GEOHAZARD ASSESSMENT PROGRAM
PEACE RIVER / HIGH LEVEL AREA
2011 INSPECTION

**Government
of Alberta** ■
Transportation

THURBER ENGINEERING LTD.

| Site Number | Location | Name | Hwy | km |
|---------------------|------------------------|------------------------|----------|---------------|
| PH57 | North of Red Earth, AB | Wabasca River Crossing | 88:16 | Approx. 52 |

FIGURE PH57-1
PH57 : HWY 88:16 - EAST OF WABASCA RIVER CROSSING
PEACE REGION (PEACE RIVER / HIGH LEVEL) GEOHAZARD ASSESSMENTS

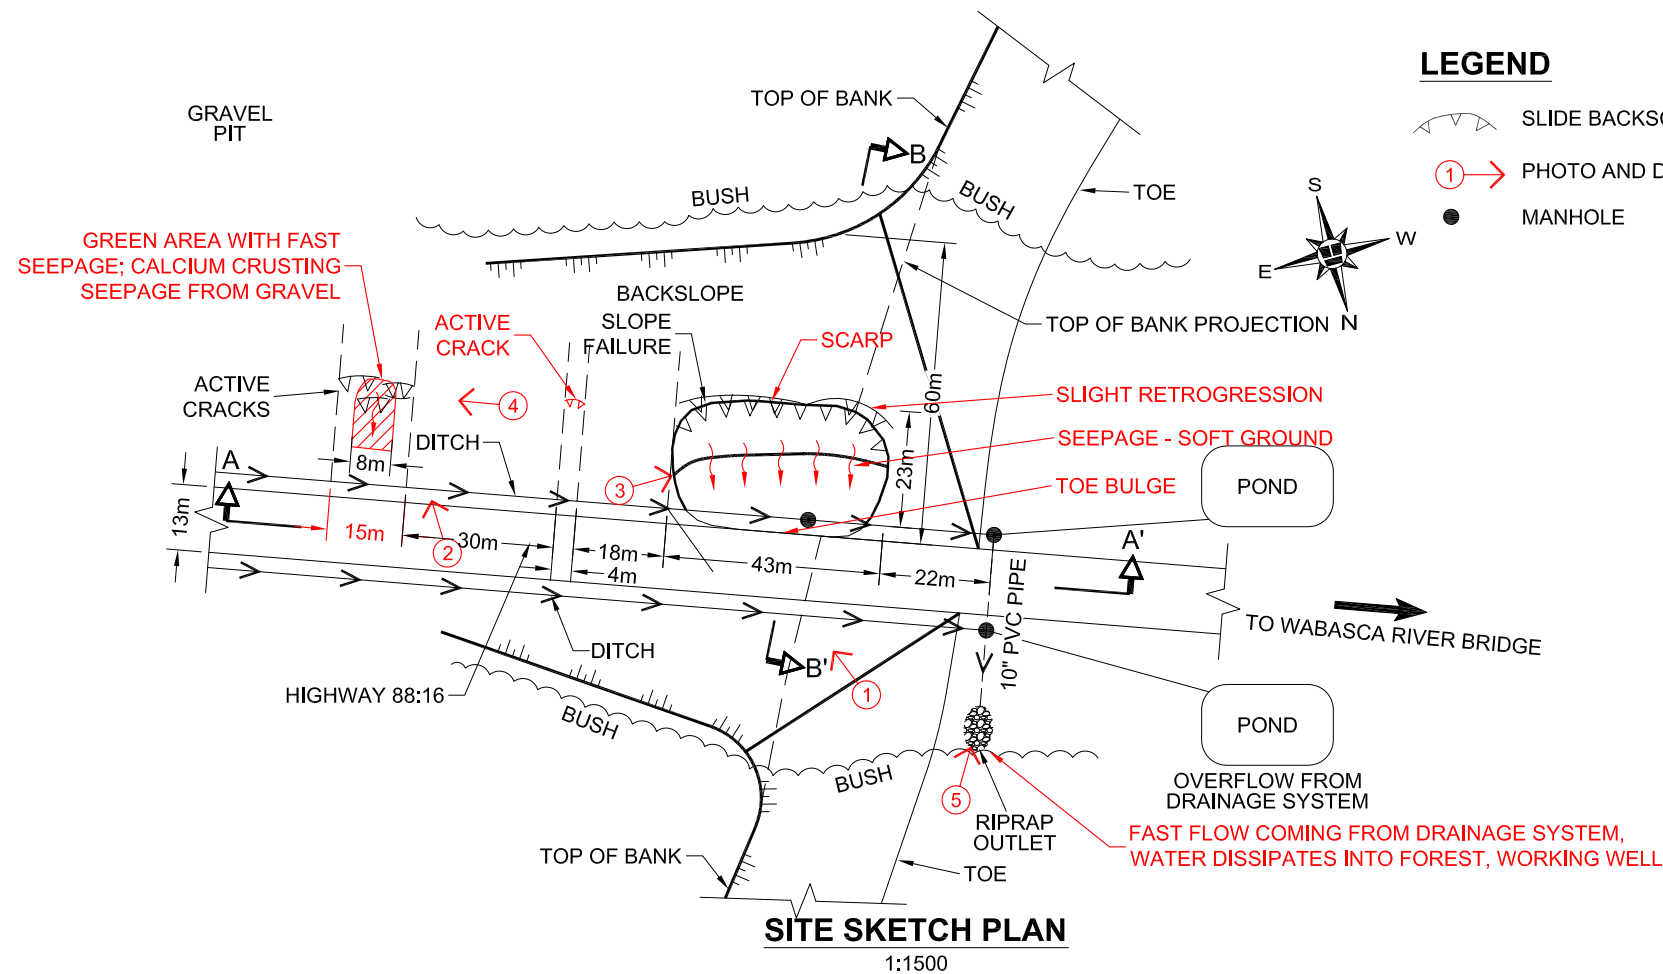
Assessment (Refer to Figure PH57-1):
The slump appears to be a shallow slope failure produced by erosion and saturation of the clay till caused by seepage from water bearing sand and gravel layers located over the clay till. Calcium crusting seepage was observed on active cracks east of the main scarp. The seepage that drains from the gravel pit to the north towards the Wabasca River appears to be intercepted by the south backslope of Highway 88. This condition is supported by the observation of the discharge draining in the south highway ditch and subdrain system, which was considerably greater than the discharge draining on the north ditch and subdrain. Fast water flow was observed through the subdrain system north of the highway and the water dissipates fast into the forest. The subsurface drainage system appears to be working well.

Seepage mitigation measures are recommended. These may consist of gravel drains installed in the south backslope to conduct the water downslope from the gravel and sand layer into the south subdrain system. For this purpose, five drains are recommended which may consist of trenches 1 m wide and 1.5 m deep excavated and backfilled with washed gravel enveloped in non-woven geotextile. The surficial 0.3 m of the excavated trenches should be backfilled with clay and topsoil and seeded. The gravel drains should be spaced about 7.5 m center-to-center across the backslope through the slump area. The upslope end of the gravel drain should extend at least 6 m (on 3H:1V inclination) upslope of the observed seepage zone. The water from the gravel drains would discharge into perforated stub pipes connecting into the top of the south ditch subdrain system at an estimated depth of about 1.5 m to 2 m. Details of the existing drainage system should be reviewed in developing the design.

After the slope drains have been installed and the slide area has dried, the slide material should be removed (taking care not to disturb the drains) and the lower slope benched and rebuilt to its original line with salvaged, moisture conditioned clay till. It should then be promptly topsoiled and seeded.

It is understood that Focus is to design remedial measures in conjunction with a base paving project and will follow Thurber's recommendations for gravel drains. AT suggests not to tie drains into the storm pipe system and would prefer to daylight drains into the ditch and then deal with ice in the ditch, if required.
